ITEM 6. SECTION 96(1A) APPLICATION: 18-20 O'DEA AVENUE WATERLOO

FILE NO: D/2013/2030/A

Proposal Summary: The subject Section 96 (1A) application seeks to modify an approved Stage 1 DA approval for a mixed use development comprising four residential flat buildings with two ground floor retail premises in the following manner:

Figure 15: Building height comparison (provided by Applicant)

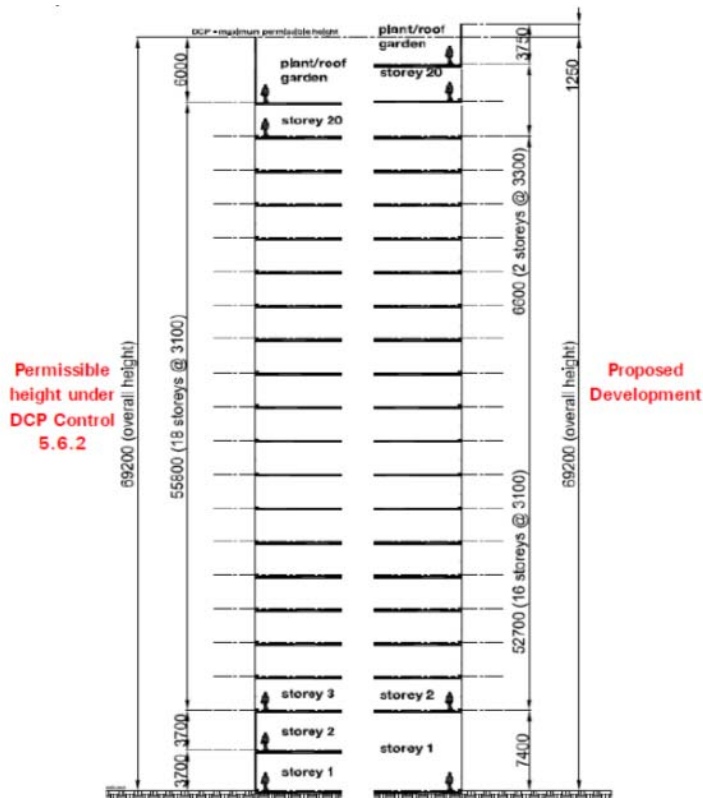
- 36. The applicant seeks consent to modify the approved envelopes to be consistent with the Stage 2 application to include apartments on the 21st floor of the tower (level 20). The additional level of apartments results from including a double height lobby of 7.4m on the ground floor of the proposed tower (Building C). The amendment is supported as:

(a) The lobby space is the equivalent of two storeys, the tower therefore only physically contains 20 storeys as shown in Figure 15 below:

- (b) The double height lobby is consistent with the original competitive design alternative process winning scheme.
- (c) The double height lobby space and varied roof form add to the architectural form and design of the building.

- (e) The non-compliance is limited to the north west component of the tower only and relates to the double height lobby. There will be no unreasonable additional overshadowing, visual or amenity impacts on the surrounding area.

- (f) The proposed additional height is marginally over the maximum that would be permitted by a compliant building with the Lachlan DCP floor to floor provisions. The remainder of the tower is below that which would be required by the DCP. This information is illustrated in Figure 16 below:

37. On the basis of the above, the proposed built form on level 20 of the tower (level 21) is considered acceptable and the condition should be amended accordingly.
